Subject: License No. SUB-1010, Docket No. 040-08027
Reclamation Plan Acceptance Review, Request for Additional
Information

ENCLOSURE 1
Sequoyah Fuels Corporation
Reclamation Plan Acceptance Review
Request for Additional Information

SFC Responses to Request for Additional Information
August 29, 2003

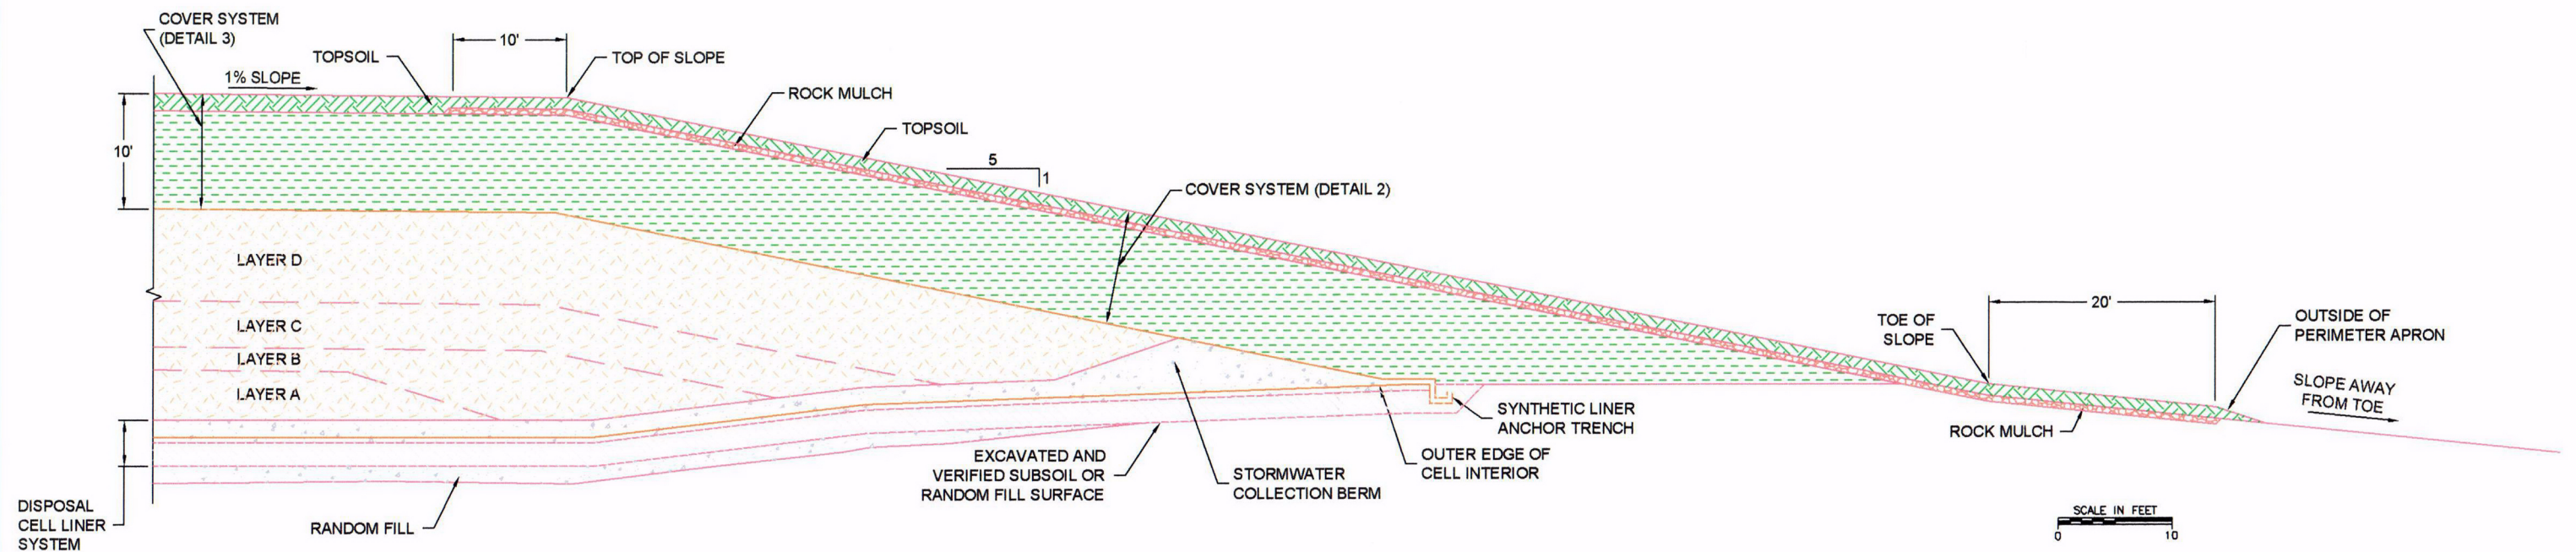
GW1. Liner configuration: According to figure 3-2, the liner will only partially underlay the tailings and will not have angled sides to the impoundment. This is not adequate from a groundwater protection perspective. In addition, the application has statements such as "if the clay liner is used." In order to review the design, staff must know what the liner material will be.

Per 10 CFR Part 40, Appendix A, Criterion 5A(2) the liner must be "installed to cover all surrounding earth likely to be in contact with the wastes or leachate." Per Criterion 5A(1) the liner must be "designed, constructed, and installed to prevent any migration of wastes out of the impoundment to the adjacent subsurface soil, groundwater, or surface water at any time during the active life (including the closure period) of the impoundment."

The original plan consisted of either a compacted clay or synthetic liner beneath Layer A materials, comprising the materials (primarily sludges) with the highest radionuclide concentrations and the most likely to be saturated. A liner system beneath the remaining materials to be disposed was not planned, since these materials are unsaturated and of similar radionuclide concentration as the remaining subsoils.

Since the original plan was proposed, ongoing testing by SFC has clarified the dewatering and treatment strategy for the sludges. In order to provide more flexibility in disposal cell operation and water management, SFC has modified the overall containment concept for the disposal cell. This concept incorporates a multilayered liner system covering the entire disposal cell base and a multilayered cover system over the disposed materials. The liner system and cover system are described below.

The liner system will include (from bottom to top): (1) compacted random fill (of variable thickness) above the excavated soil surface to achieve desired slopes, (2) a 24-inch thick layer of compacted clay (from on-site sources), (3) a 6-inch thick layer of sand (from off-site sources) as a bedding layer, (4) a synthetic liner, (5) an 18-inch thick layer of sand (from off-site sources) as a protective layer and

drainage layer above the synthetic liner. The two sand layers will include a grid of slotted pipe sloped to drain to two external sumps at the southwest corner of the disposal cell. The sumps will serve as monitoring locations for leachate collection (above the synthetic liner) and leak detection (beneath the synthetic liner).

The cover system will include (from bottom to top): (1) a compacted and smoothed disposed material surface to provide a bedding layer, (2) a synthetic liner, (3) a 1.5-foot thick layer of cover soils or sand (from on-site or off-site sources) as a protective layer and drainage layer above the synthetic liner, (4) a 7-foot thick layer of cover soils (from on-site sources), and a 1.5-foot thick layer of topsoil and erosion protection material. The upper 1.5-foot thick layer will consist of entirely topsoil (from on-site sources) on the top surface of the disposal cell, and a 1.0-foot thick layer of topsoil above a 0.5-foot thick layer of rock mulch (from off-site sources) on the side slopes of the disposal cell.

The synthetic liner to be used in the disposal cell liner system and cover system will most likely be a 60-mil thickness high-density polyethylene that is installed, seamed, and tested according to current liner construction practices. The two synthetic liners will be anchored together along the perimeter of the disposal cell to form a complete geomembrane system around the disposed materials. Long-term containment will be provided by the cover soils and clay liner.
